Reviewer 1: The authors present a numerical study of concentrated photovoltaic-thermal solar collectors with spectral beam splitters. I really enjoyed reading the manuscript and how the information was presented. However, I think the work could be improved if the following comments are considered:

Figure 1. Meshed CPV-T collector.

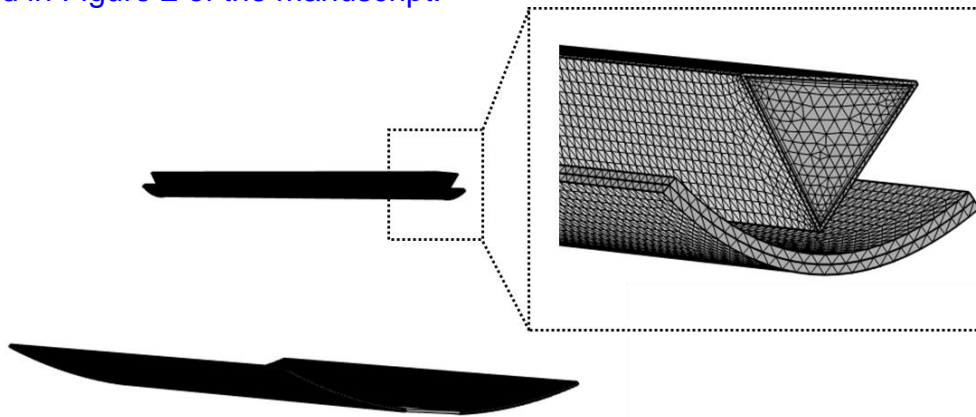
A figure with the mesh and boundary conditions applied would help clarify how the numerical simulations were performed.

The authors would like to thank the reviewer for the suggestion. This has been included in Figure 2 of the manuscript.
